REGIONAL REVIEW NOTICE

ARC REVIEW CODE: R1607141

Name of Proposal: Destinations at Mall of Georgia

Review Type: DRI

SITE

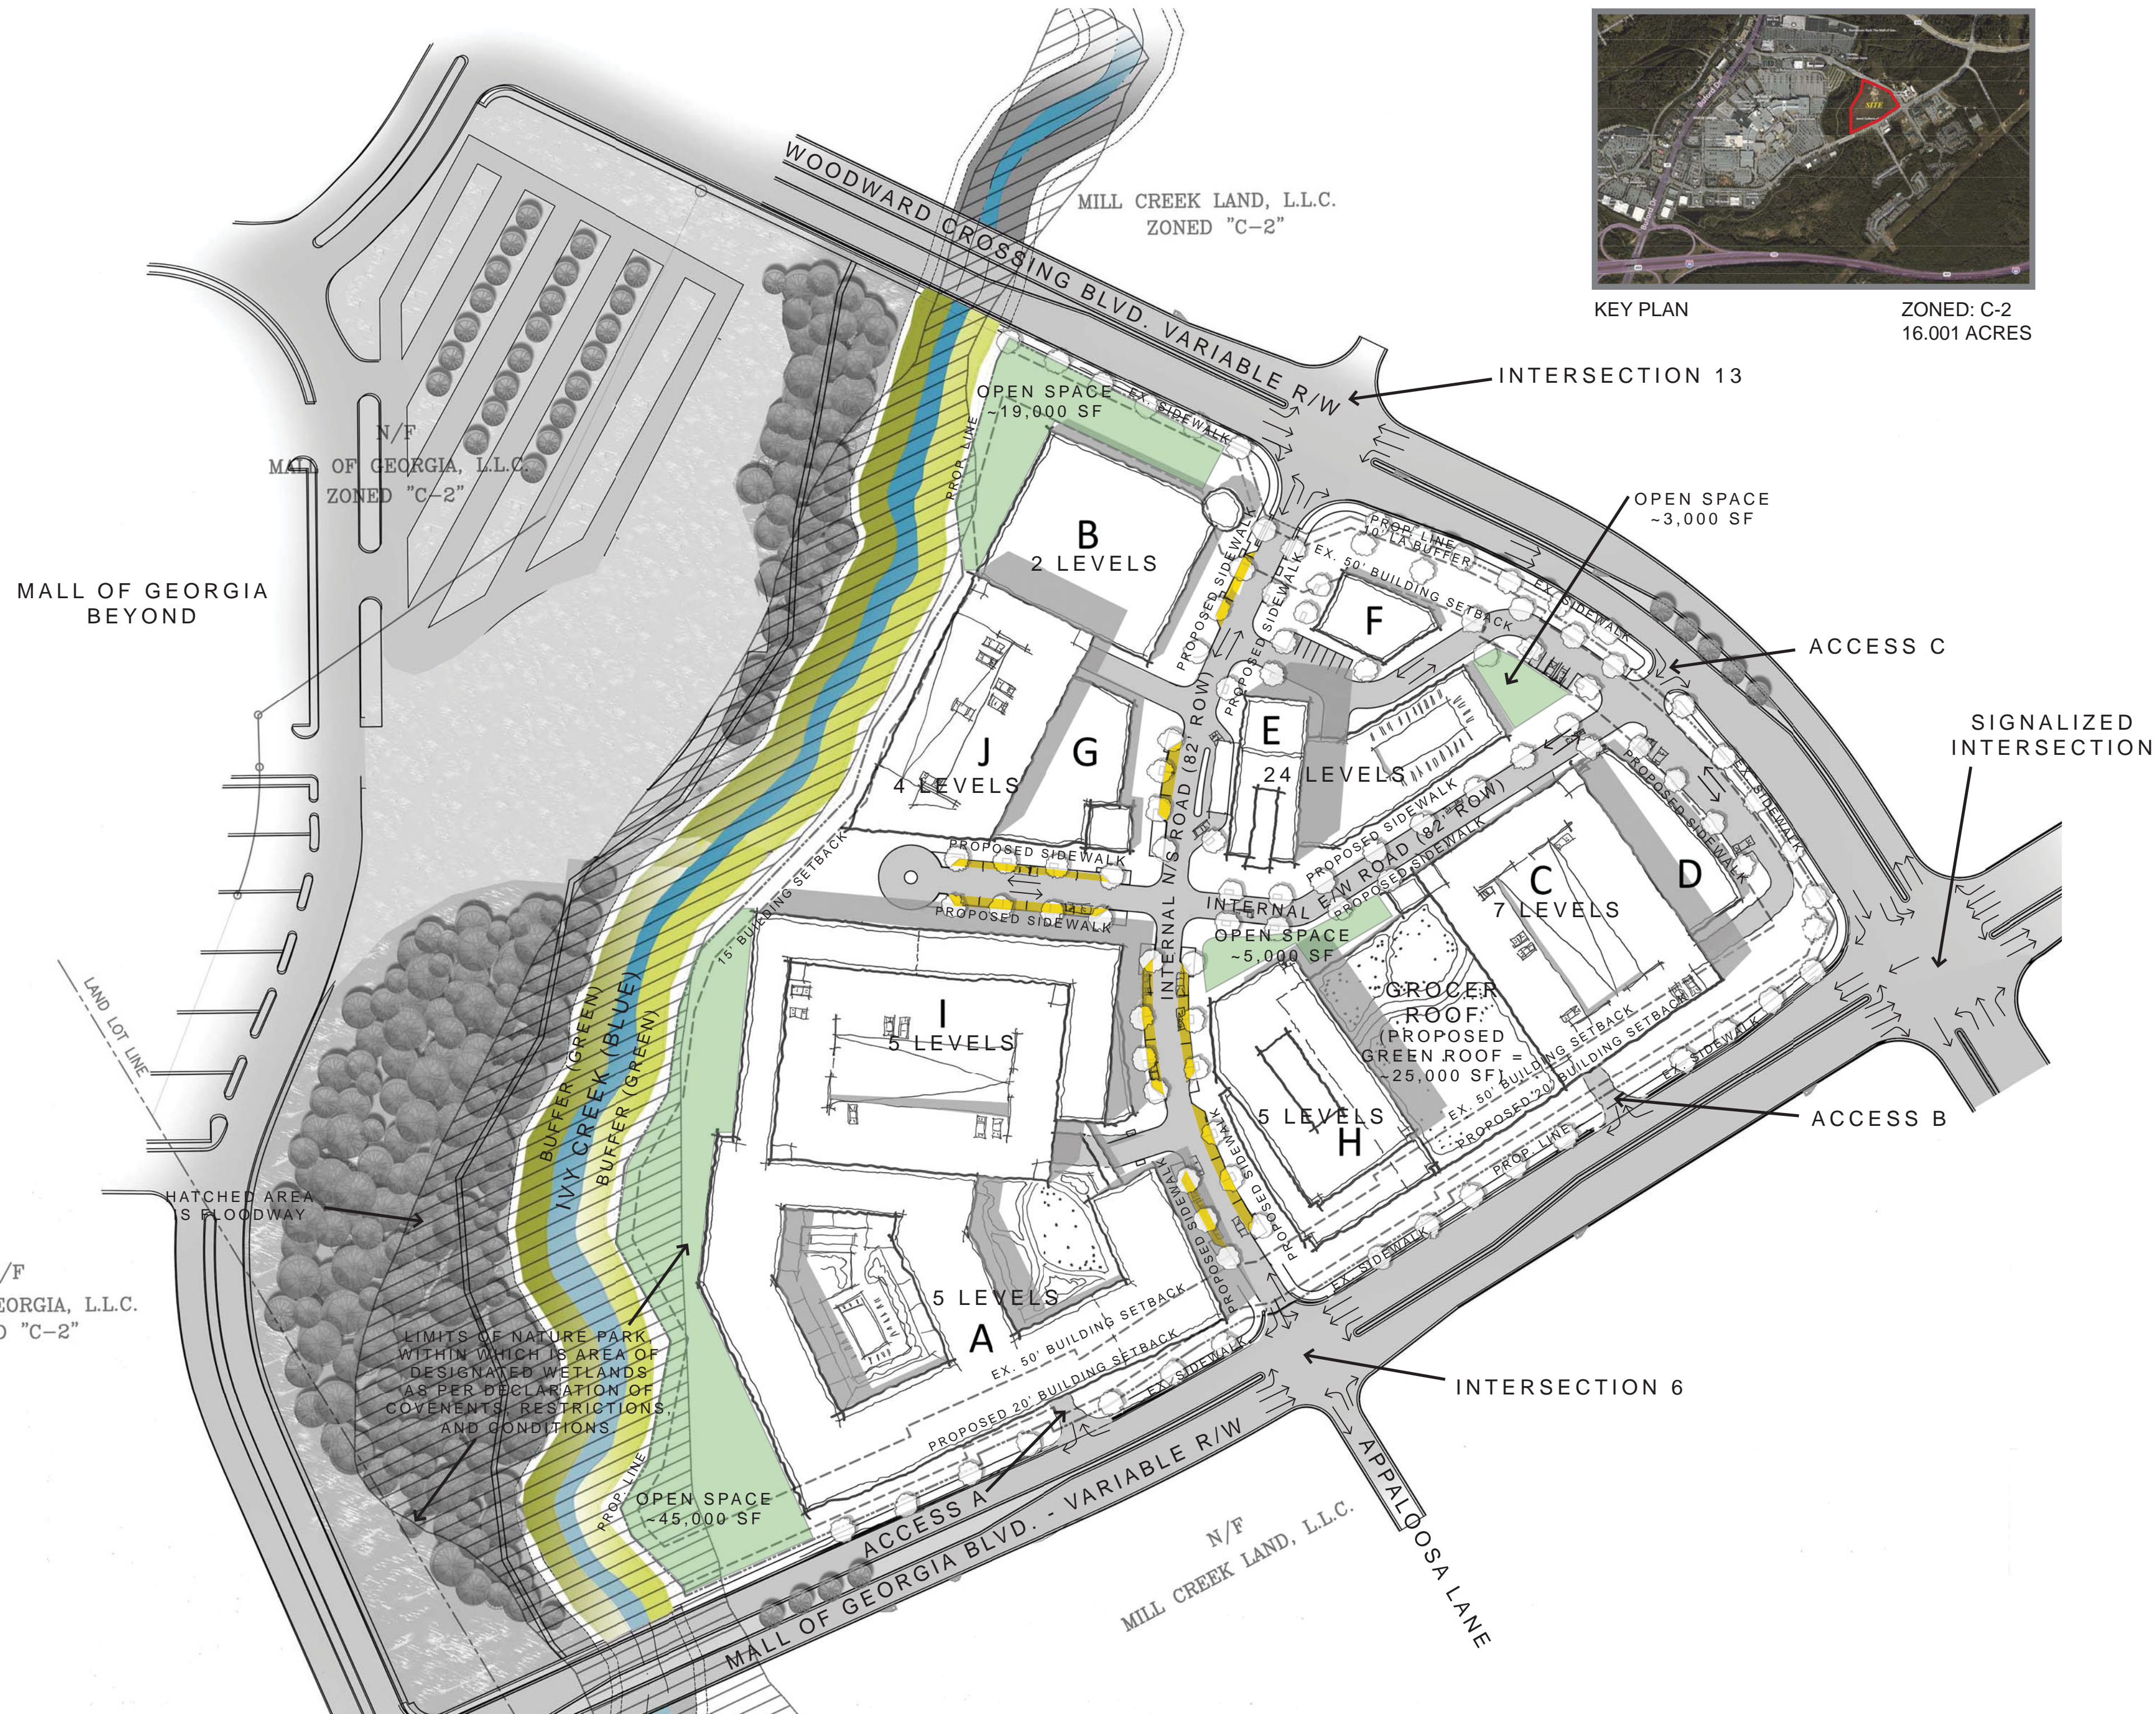
Along these lines, care should be taken to ensure that the development promotes a functional, safe, clearly marked and comfortable pedestrian experience on all streets, paths and parking areas, as well as all connections from the project to neighboring uses. This includes the DRI's perimeter along Woodward Crossing Boulevard and Mall of Georgia Boulevard. Placing buildings closer to the street and providing wide sidewalks on both frontages (not just Mall of Georgia Boulevard where the applicant is proposing a shallower setback than is required by code) would create a more comfortable pedestrian experience.

Also related to pedestrian experience and access, ARC encourages the development team to pursue construction of the proposed pedestrian bridge from the DRI's internal east-west road over Ivy Creek to the Mall of Georgia, within the framework of applicable environmental requirements. This bridge connection was discussed in pre-review meetings and shown in the GRTA-required traffic study and on previous iterations of the site plan, but it is absent from the final site plan provided for this review. The development team is also encouraged to ensure that end-of-trip facilities (bicycle racks, etc.) are provided at key locations throughout the site.

Both the submitted site plan and the USGS coverage for the project area show Ivy Creek, a blue line stream, running along the western edge of the project area, between this property and the Mall of Georgia. No other streams are shown as on or near the property on the USGS coverage. Ivy Creek is a tributary of Suwanee Creek, which flows into the Chattahoochee River. Shaded areas shown on both sides of Ivy Creek for the length of the property are identified as buffers. However, based on the site plan scale, the buffers shown are not as deep as the County's required buffers, which include a 50-foot stream buffer and additional 25-foot impervious setback. Based on the site plan scale, portions of Buildings A, B, I and J appear to be within the County buffer and setback. The plans should accurately show the depth of the County buffer and setback, and should also show the 25-foot State Sediment and Erosion Control buffer, with all buffers and setbacks clearly identified. Any unmapped streams on the property may also be subject to the requirements of the County stream buffer ordinance. Any unmapped state waters on the property will be subject to the State 25-foot Erosion and Sedimentation buffer requirement. Intrusions into the County buffer or setback may require a variance from the County. Any intrusions into the State 25-foot Erosion and Sedimentation buffer may also require a variance.

The proposed pedestrian bridge across Ivy Creek linking the development site with the Mall of Georgia will intersect the greenway. It is currently unpaved in this section.

The proposed pedestrian bridge should be built to also accommodate bicyclists. The path in the immediate area is unpaved, but it does connect with a paved trail to the southwest near the SR 20 / I-85 interchange.

The site is proposed to be connected to the Mall of Georgia via a pedestrian bridge over Ivy Creek. This bridge should also be constructed to accommodate bicyclists using the Ivy Creek Greenway, particularly in the event that the trail in this area is paved in the future.

A small grocery store and some retail space is proposed, but the size is not likely to generate a significant amount of truck traffic. However, it is unclear from the site plan where trucks would service those businesses without blocking internal drives and/or sidewalks.
